**TOWN OF LOOMIS** 3665 Taylor Road P.O. Box 1330 Loomis, CA 95650 (916) 652-1840

PROJECT: Storm Drain Culvert Replacement Project #22-14

SUBJECT: ADDENDUM NO. 2

SHEET NUMBER 22 of 30

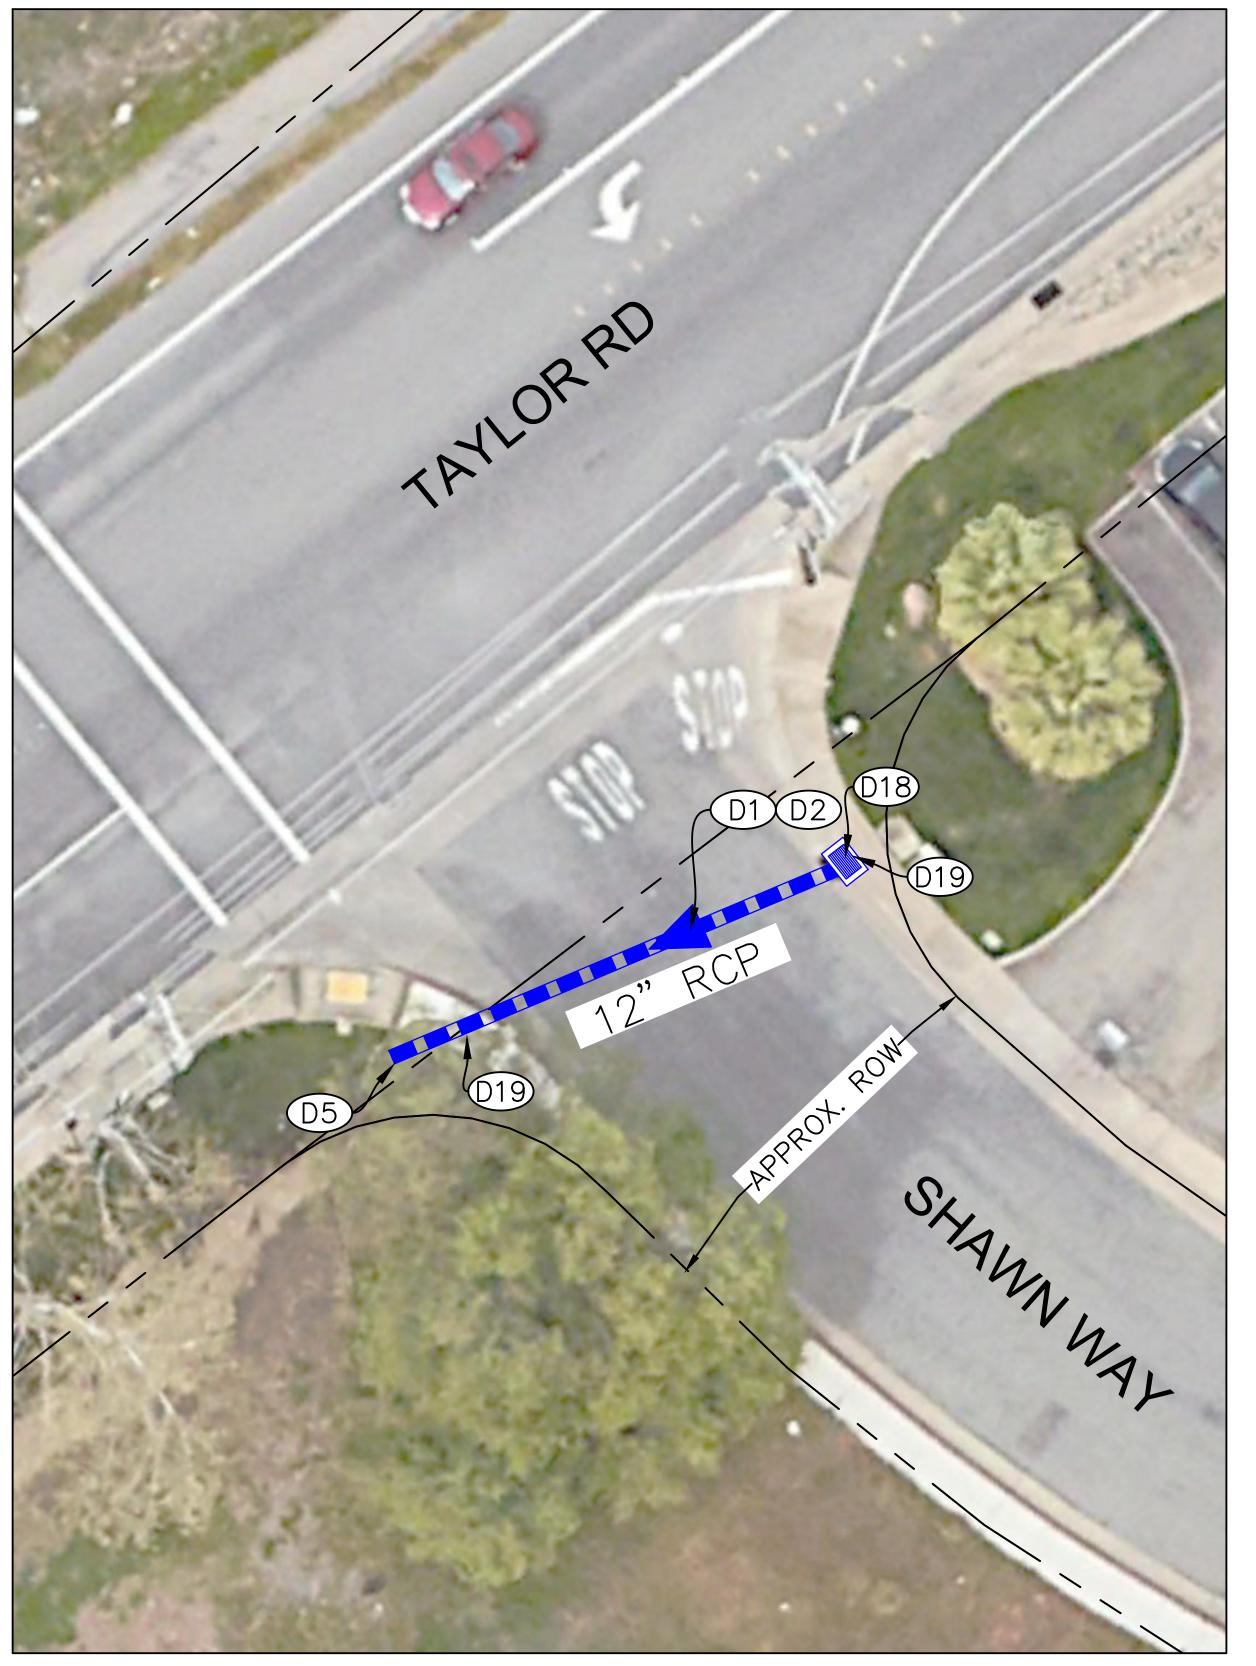
Addendum Item	Contract Document	Part/Section	Description of Change
1. Updated Bid Bond Form	Specifications	Page B-11 Bid Guarantee Form	Please use the revised Bid Guarantee Form (Attachment A; 1 page)
2. Updated Sheet 22	Plans	Sheet 22 of 30	Please replace Sheet 22 of the plans with the revised Sheet 22. (Attachment B; 1 page)

- 1. Q: Will the Town allow ADS HP storm pipe instead of the RCP pipe called out on the plan? A: No. The Town will require RCP to be installed where called out on the plans.
- 2. Q: Page 22 of 30 Plans says 12" RCP but Note 1 says 12" HDPE. Could you please clarify?

A: The intention is to have 12" RCP installed at Location #22, shown on Sheet 22. Please see

Addendum Item Number 2 in the table above and Attachment B to this Addendum for correction.
- 3. Q: Is there a rock clause for this project if the contractor should run into it during excavation?

- REMOVE EXISTING 12" CMP AND INSTALL APPROXIMATELY 55 LF OF 12" RCP STORM DRAIN PIPE. SLOPE TO DRAIN AT MINIMUM 0.5% OR MATCH EXISTING SLOPE, WHICHEVER IS GREATER. INFORM ENGINEER IF MINIMUM SLOPE OF 0.5% IS NOT ACHIEVABLE.
